SERVICE BULLETIN

B-034

RECALL CAMPAIGN 0821 - RACE MUFFLER RETENTION KIT

Figure 1. Installing Retention Cable and Clamp

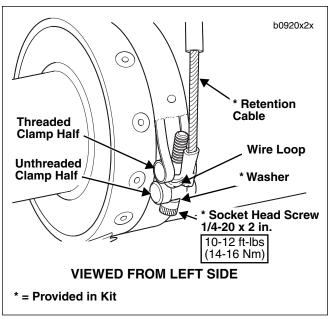
Buell Motorcycle Company has learned that certain Buell Pro Series Race Systems contain a muffler that could break. This condition could allow the muffler to drag on the ground, which may adversely affect handling and could cause an accident. Accordingly, Buell Motorcycle Company is voluntarily conducting a recall campaign to formally recall all potentially affected mufflers.

- 2. Disconnect negative battery cable from battery terminal.
- 3. See Figure 1. Using a Scotch-Brite pad, thoroughly clean front portion of muffler where clamp will be installed.

- 6. See Figure 2. Position **new** clamp on front of muffler so clamp hardware will be located on outboard side.
- 7. See Figure 1. Install **new** socket head screw and washer from bottom through unthreaded clamp half. Position retention cable wire loop between two clamp halves and finish installing socket head screw through wire loop and the threaded clamp half. NOTE: When properly installed, there should be no tension on the cable.

- 8. See Figure 1. Tighten clamp screw to 10-12 ft-lbs (14-16 Nm).

Figure 2. Retention Cable Installed

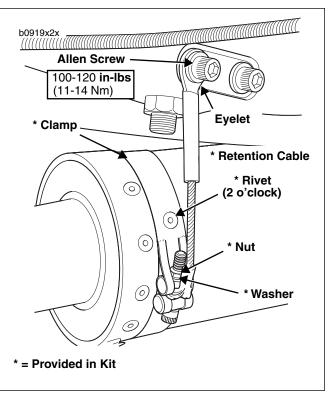
- See Figure 2. Remove front allen screw on left lower side of the primary cover. Install retention cable eyelet with front allen screw finger tight. NOTE: On X1 models or models equipped with chin fairings, remove spacer between chin fairing and primary cover.

- Remove front allen screw and retention cable eyelet from primary cover to allow access for performing steps 10-13.
- 10. See Figure 2. Install hex nut and washer to clamp screw and tighten nut.

- 11. Using a center punch, dimple the muffler at the center of the pre-drilled clamp hole at the 2 o'clock position.
- 12. See Figure 2. Using a #11 drill bit (0.190 in.), drill through the muffler at the 2 o'clock position.
- 13. Using a pop rivet gun, install rivet provided in kit to locate clamp on muffler.
- 14. See Figure 2. Install retention cable eyelet to primary cover with allen screw. On X1 models or models equipped with chin fairings, remove 0.120 in (3 mm) of material from inboard (non-stepped) side of spacer with a lathe or file. Reinsert spacer between eyelet and chin fairing, stepped side outboard. Eyelet will be located between the primary cover and the spacer. Tighten allen screw to 100-120 **in-lbs** (11-14 Nm).
- 15. Connect negative battery cable to negative battery terminal. Tighten to Service Manual specifications.
- 16. See CREDIT PROCEDURE.
